# How to Change Antenna Diversity Settings

The following document contains new antenna setup and operation procedures implemented with X-System firmware version 1.1.

Figure 1: X-Ware Device Management Tab and Radio Transceivers List View

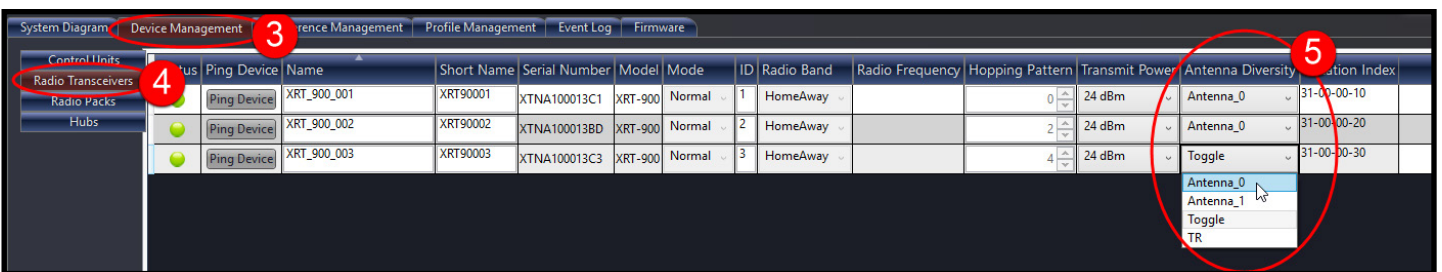
1. Connect and power on your system, select **Home** or **Away** on the master CU, and allow your CCF to load.
2. Open X-Ware and tap the gears icon in the upper right corner to open X-Ware’s Advanced Settings window.
3. Click on the “Device Management” tab of the advanced settings window.
4. Click on the “Radio Transceivers” option in the sub-menu that displays on the Device Management tab. A table of the system’s RTs will display.
5. Find the Antenna Diversity column, and select **Antenna\_0** from the drop-down field for each RT in the table.

Figure 2: Top View of RT

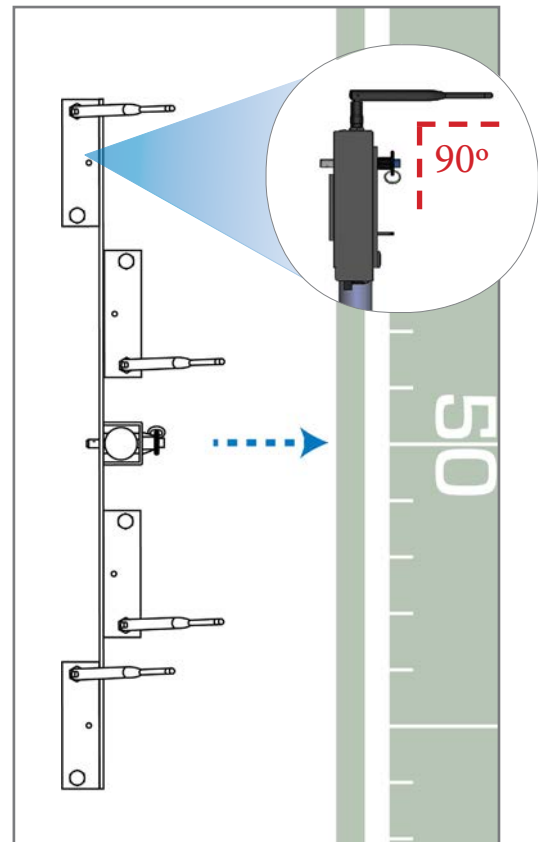
1. Identify the right or “R” connector on the top of each RT. It is the right-hand connector when you can read “PING” properly from left to right on top of the RT.
2. Attach a whip antenna to each RT’s “R” connector. Remove each “L” whip antenna and keep them with your system as spare parts. Each RT should resemble Figure 2.
